SUBJECT: ORDER FOR MODIFICATION OF LICENSE CONCERNING PRIMARY COOLANT
SYSTEM PRESSURE ISOLATION VALVES

ORDER FOR MODIFICATION OF LICENSE

SAFETY EVALUATION REPORT
JOSEPH M. FARLEY NUCLEAR PLANT, UNIT NO. 1
PRIMARY COOLANT SYSTEM PRESSURE ISOLATION VALVES
(WASH-1400, EVENT V)

**PRIMARY COOLANT SYSTEM
PRESSURE ISOLATION VALVES**

Figure 1. Valve Configurations Designated by the NRC To Be Included in This Technical Evaluation

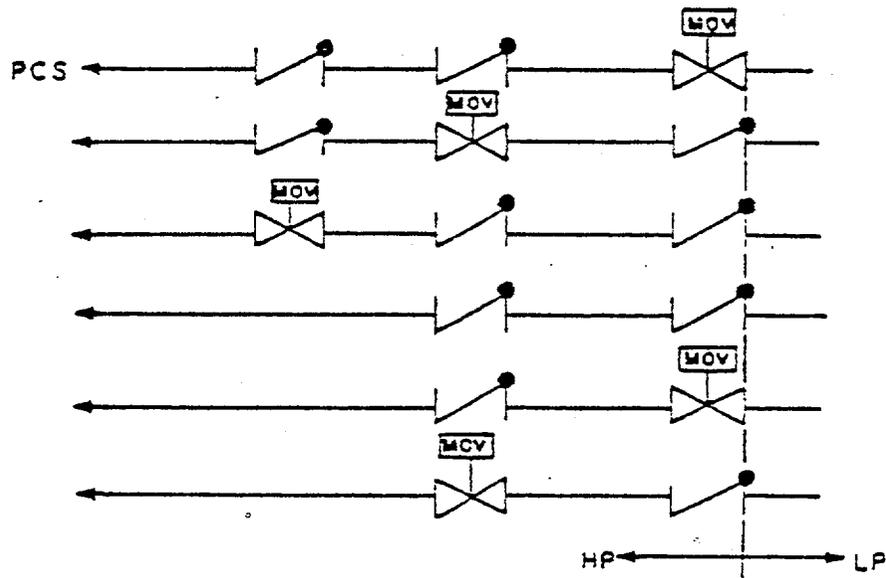
Nevertheless, the Low-Head Injection System hot-leg was discovered by FRC to contain a valve configuration of concern.

The piping system of concern in the Low-Head Injection System leading to the hot-leg side of the Primary Coolant System Loops 1 and 2 consists of two piping branches each having a two check valve in-series configuration with both branches joining at a single motor-operated valve (MOV) outside containment. The high-pressure/low-pressure interface is on the upstream side of the single MOV. The valves of concern in this system are listed below:

Based on the previously docketed information and drawings made available for FRC review, FRC found that the hot-leg branches of the Low-Head Injection System in Farley Unit 1 contain a valve configuration of concern (identified in Figure 1). Thus, if the licensee's review of the valving configurations in the hot-leg branches of the Low-Head Injection System confirms FRC's finding, then the valve configurations of concern existing in Farley Unit 1 incorporate the valves listed in Table 1.0.

If APC modifies the Plant Technical Specifications for Farley Unit 1 to incorporate periodic testing (as delineated in Section 2.2) for the check valves itemized in Table 1.0, then FRC considers this an acceptable means of achieving plant compliance with the NRC staff objectives of Reference 1.
